ADDENDUM NO. 1

to **CONTRACT DOCUMENTS** for

Redwood Avenue Street Improvements Phase 2
Project No. TR4934
Grants Pass, Oregon

SITE PREPARATION AND PEDESTAL INSTALLATION
CBU TYPES I, II, III, AND IV

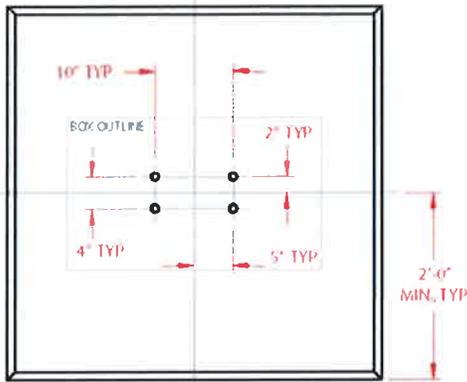
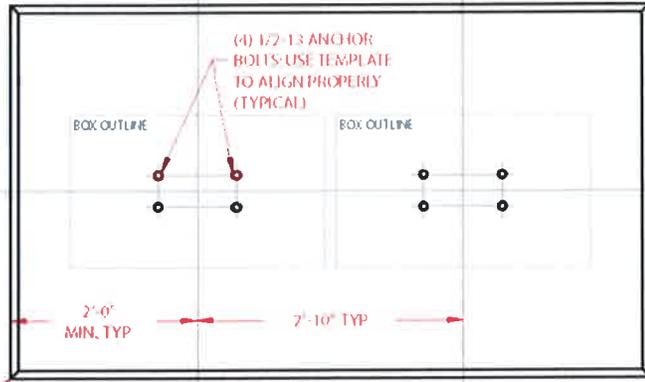
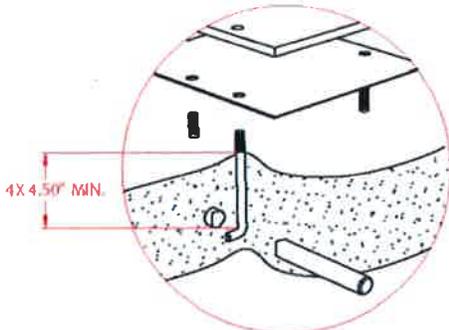
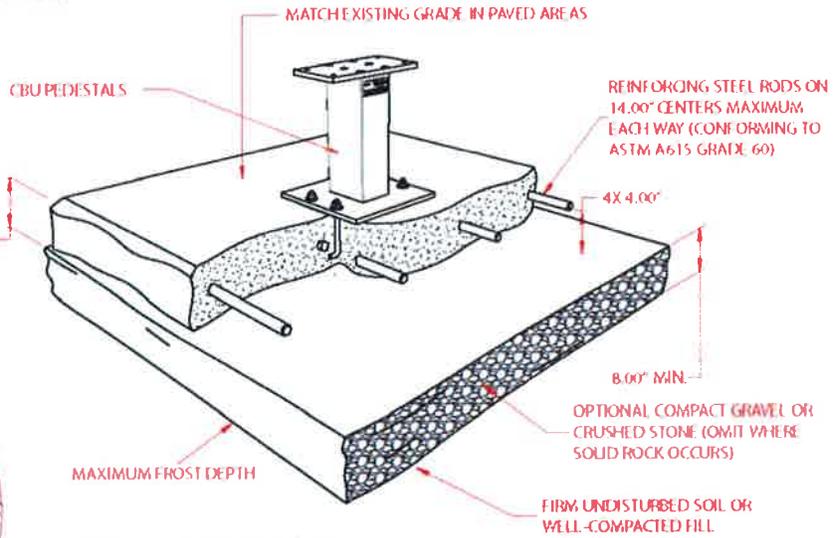
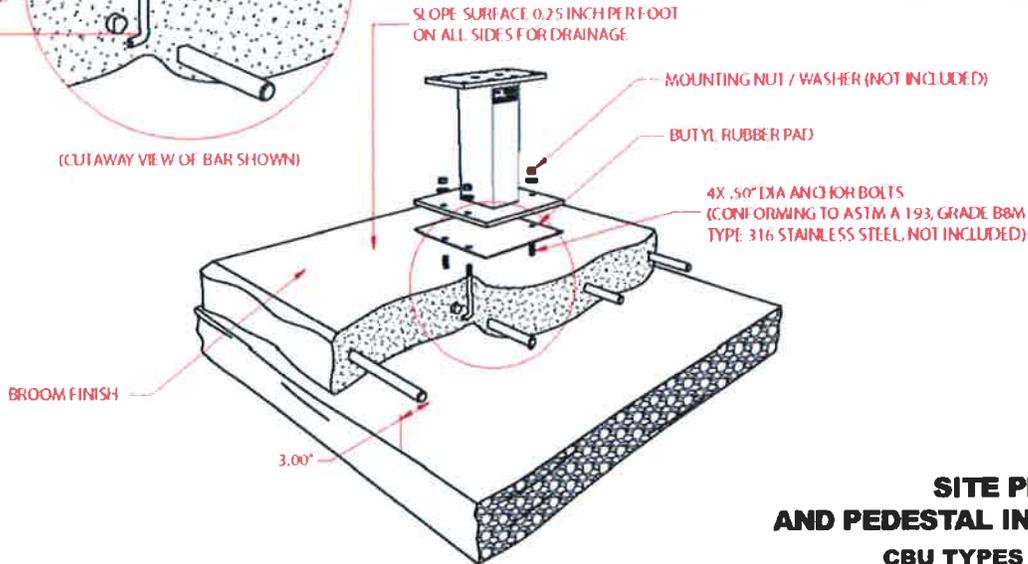
- **Shared Mailboxes:**
 - Shared Mailboxes are to be *supplied* and *installed* by the contractor. See attached product installation details, plan locations, and revised bid item #103. All shared mailbox units shall be gray in color and include reinforced concrete pad.

- Station: 9+54.05 = 8 unit box (Type I)
 - Station: 14+52.90 = 12 unit box (Type II)
 - Station: 20+41.94 = 12 unit box (Type II)
 - Station: 26+03.05 = 16 unit box (Type III)

- Station: 30+25.19 = 12 unit box (Type II)
 - Station: 34+54.62 = 8 unit box (Type I)
 - Station: 39+02.35 = 12 unit box (Type II)
 - Station: 46+86.73 = 16 unit box (Type III)

- Station: 50+10.40 = 16 unit box (Type III)
 - Station: 51+67.82 = 12 unit box (Type II)
- **Construction Speed Reduction:**
 - A construction speed 35 MPH shall be provided on both ends of Redwood Avenue for the duration of the project.
